Architectural Review Board Staff Report

Project Type: Amended Architectural Elevations

Description: **Four Seasons Plaza West AAE:** Amended Architectural Elevations and Architect's Statement of Design for a 2.35 acre tract of land zoned "PC" Planned Commercial District located on the south side of Olive Boulevard, west of River Valley Drive.

Proposed Elevations

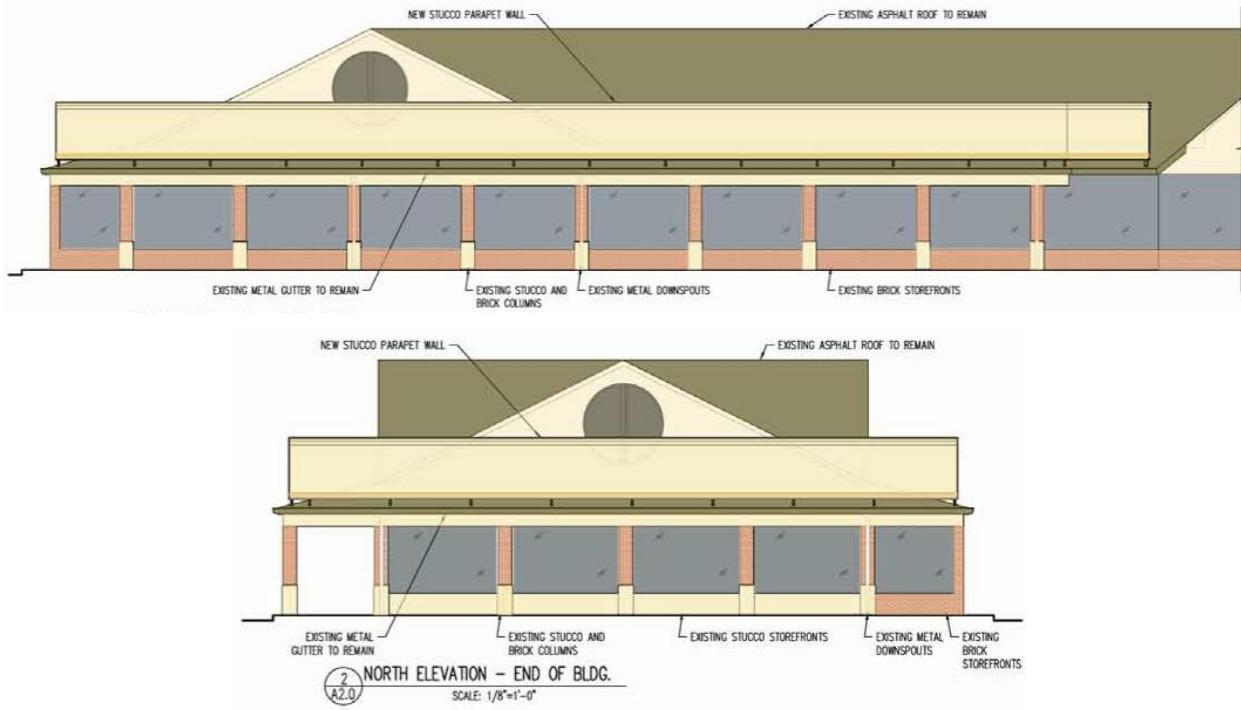
The proposed parapet wall will increase the vertical height of the flat façade of the existing structure. Although the building scale will appear slightly larger to pedestrians, the proposal is consistent with the height of adjacent structures in the Four Seasons Plaza development directly to the East.

Per the City's design standards, parapet walls should be treated as an integral part of the architecture and shall not visually weaken the design of the structure. The nature of this parapet wall as an addition on top of the existing hip and gable style roof does not allow for the integration into the existing architecture. The use of parapet walls is generally found with flat roof styles throughout the city including the adjacent developments. When used in conjunction with the hip and gable style roof, the parapet wall provides a slight interruption to the existing rhythm of the building's façade.

The proposed parapet wall will be composed of stucco on the exterior to match the existing gable materials and will also incorporate the same paint color that will be used on the existing stucco gables for the dominant color. A complementary accent color is proposed along the bottom edge of the stucco parapet wall to provide slight variation in the design.

Signage is not part of the proposal before Architectural Review Board and will be reviewed by Staff. However, it is important to note that this proposed parapet wall will increase the vertical façade of the building and thus the opportunity for wall-mounted signage.

Although the proposed changes are not fully integrated into the existing roof structure, the applicant has made efforts to use materials and colors that will provide some consistency with the existing structure. Staff requests action on the Amended Architectural Elevations and Architect’s Statement of Design for Four Seasons Plaza West.
